## PIC16C63A Rev. A Silicon Errata Sheet

The PIC16C63A (Rev. A) parts you have received conform functionally to the Device Data Sheet (DS30605A), except for the anomalies described below.

**FIGURE 1:  $\overline{\text{MCLR}}$  EXTERNAL CIRCUIT**

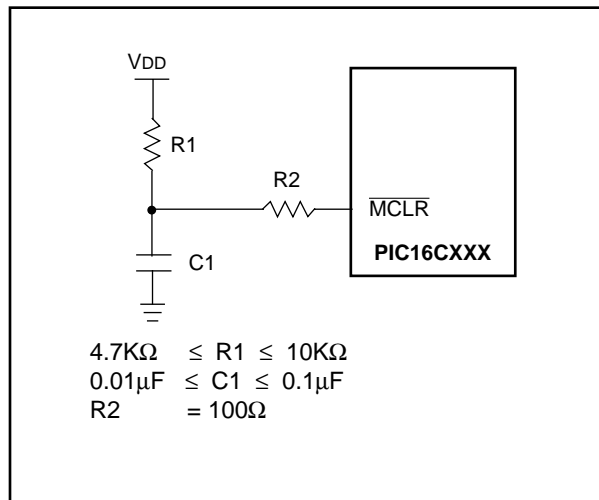
The minimum specification for the  $\overline{\text{MCLR}}$  must be met in order to RESET the PIC16CXXX. If a  $\overline{\text{MCLR}}$  pulse occurs that is less than the minimum specification (parameter #30), improper device operation can occur.

If the Minimum specification cannot be met, then an external circuit must be used to insure that any pulse width less than the specification will be filtered before it reaches the  $\overline{\text{MCLR}}$  pin.

A possible circuit is shown in Figure 1. Proper design validation needs to be done to ensure desired operation over the applications operating conditions

**Figure 1: Wake-up from Sleep**

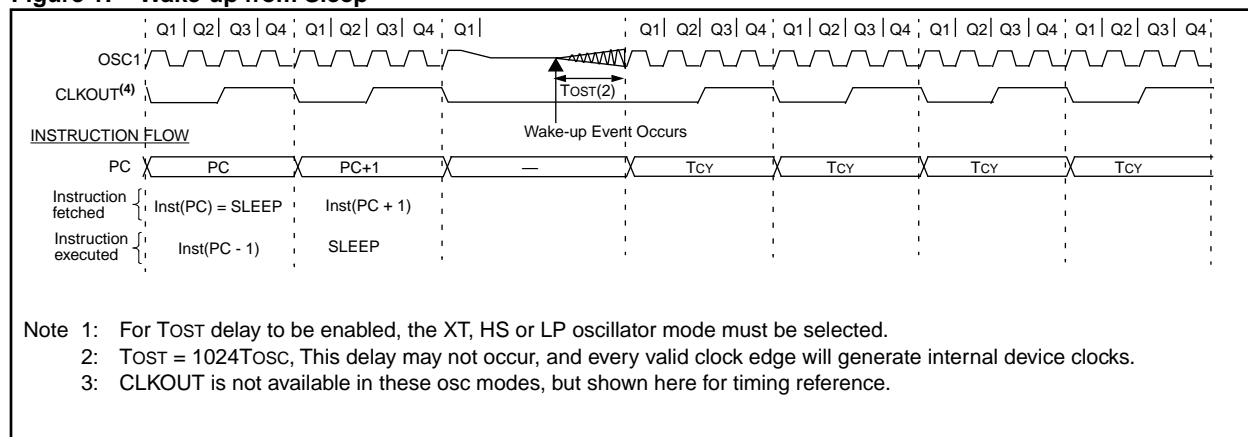
The Oscillator Start-up Timer (TOST) delay may not occur when the device wakes-up from sleep.

Figure 1 shows the start-up of the crystal after the event that causes the device to wake up from sleep mode (as specified in device data sheet). The start-up time (TOST) may not occur.

After the SLEEP instruction, do a software delay of 256 Tcy (same as 1024 TOSC). At the Reset and Interrupt vector addresses, test to see if the device woke from sleep (the  $\overline{\text{TO}}$  and  $\overline{\text{PD}}$  bits), and if the device did wake from sleep, ensure that the total cycle delay is 256 Tcy.
